UNITED STATES
DEPARTMENT OF THE INTERIOR
BUREAU OF LAND MANAGEMENT

SUNDRY NOTICES AND REPORTS ON WELLS
Do not use this form for proposals to drill or to re-enter an abandoned well. Use form 3160-3 (APD) for such proposals.

1. Type of Well <input checked="" type="checkbox"/> Oil Well <input type="checkbox"/> Gas Well <input type="checkbox"/> Other		8. Well Name and No. SEMU 128
2. Name of Operator CONOCOPHILLIPS COMPANY		9. API Well No. 30-025-34313-00-S4
3a. Address MIDLAND, TX 79710		10. Field and Pool, or Exploratory Multiple--See Attached
3b. Phone No. (include area code) Ph: 432-688-9174		11. County or Parish, and State LEA COUNTY, NM
4. Location of Well (Footage, Sec., T., R., M., or Survey Description) Sec 24 T20S R37E NESE 2490FSL 1310FEL

SEMU-128
Procedure to P&A
API#30-025-34313

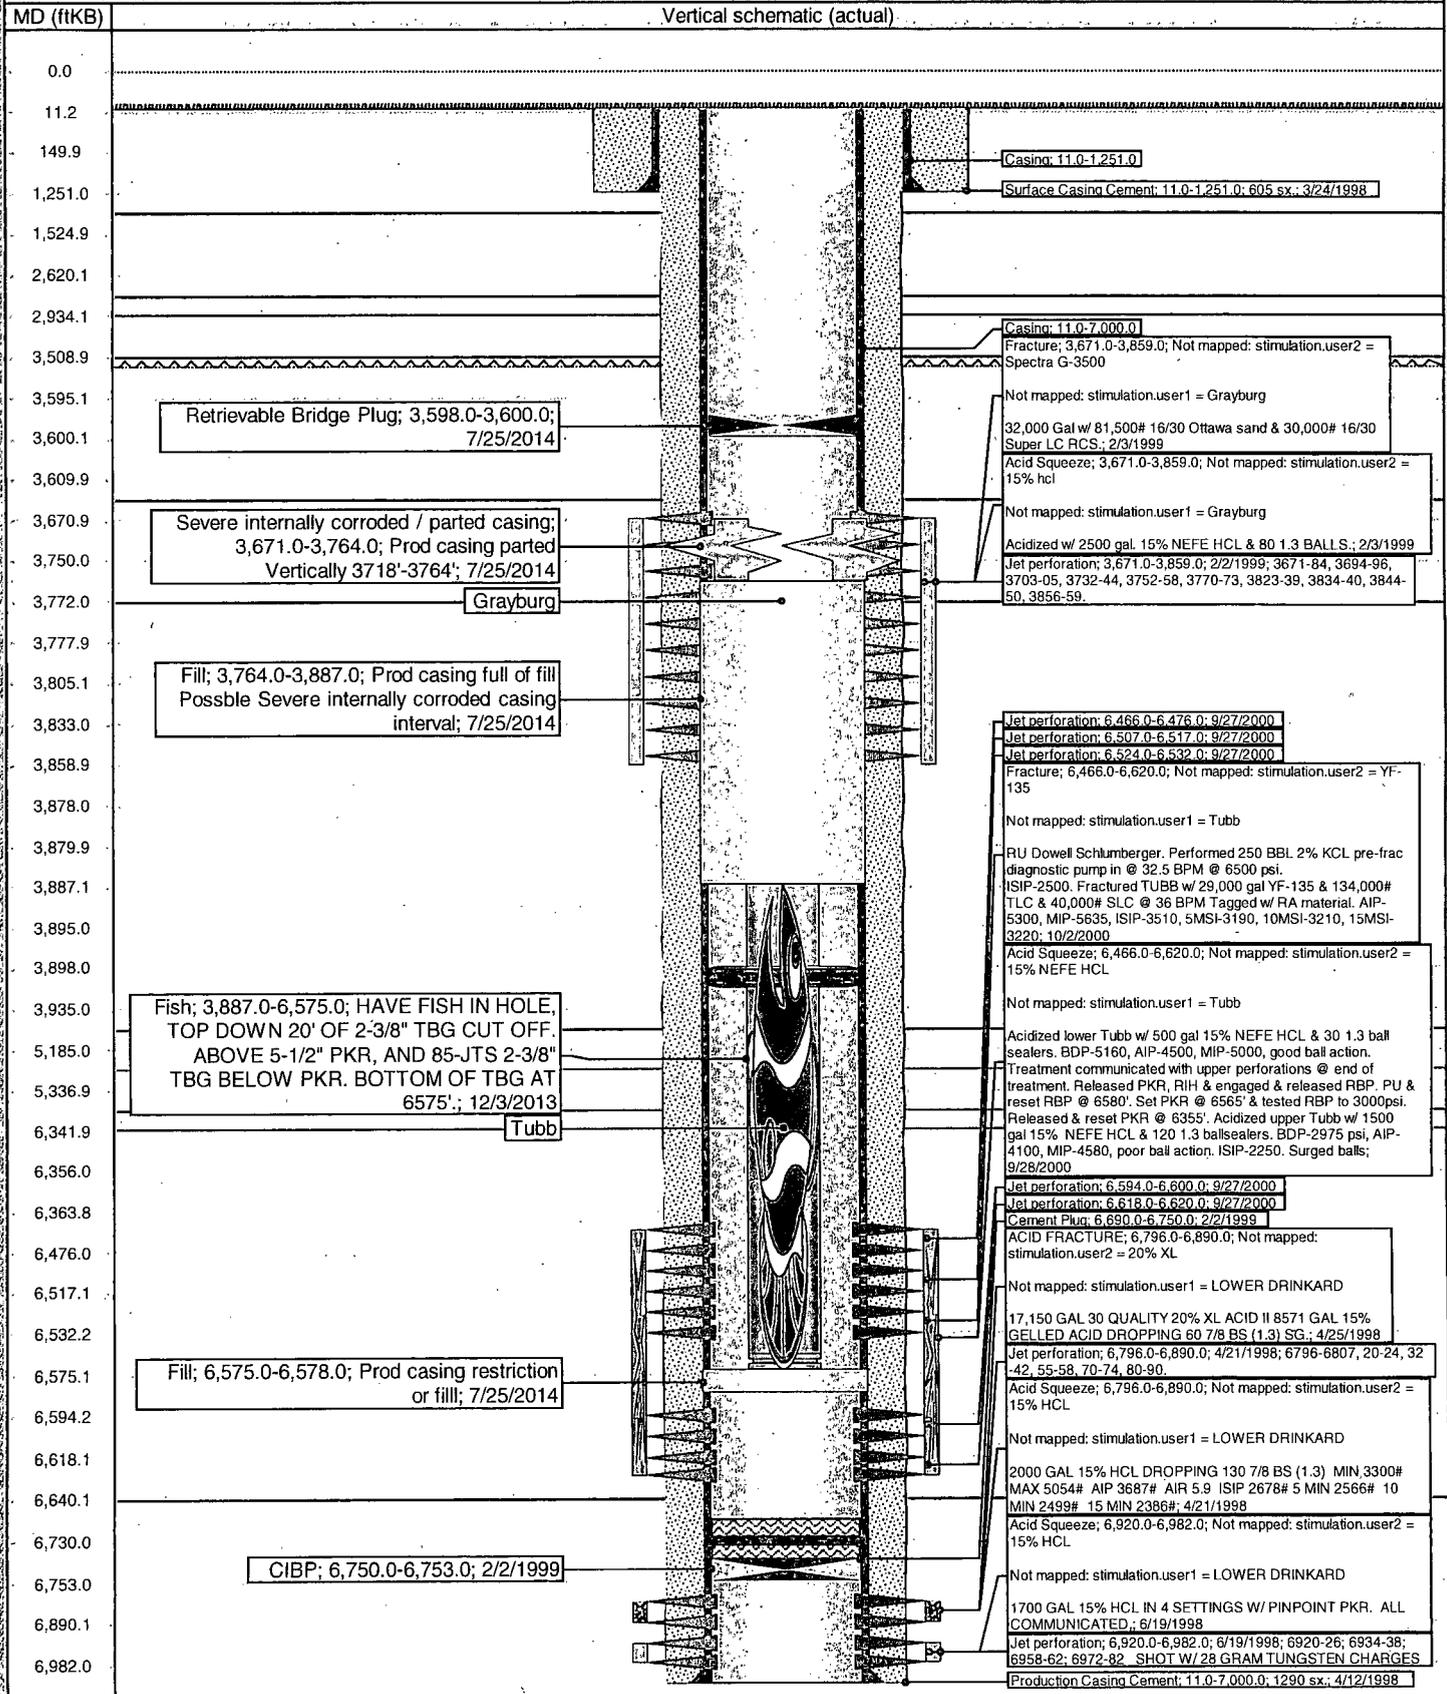
*RIH to PBD Spot
 cut across Tubbs Acctg
 from 6670 - 6300. woc
 Tag.*
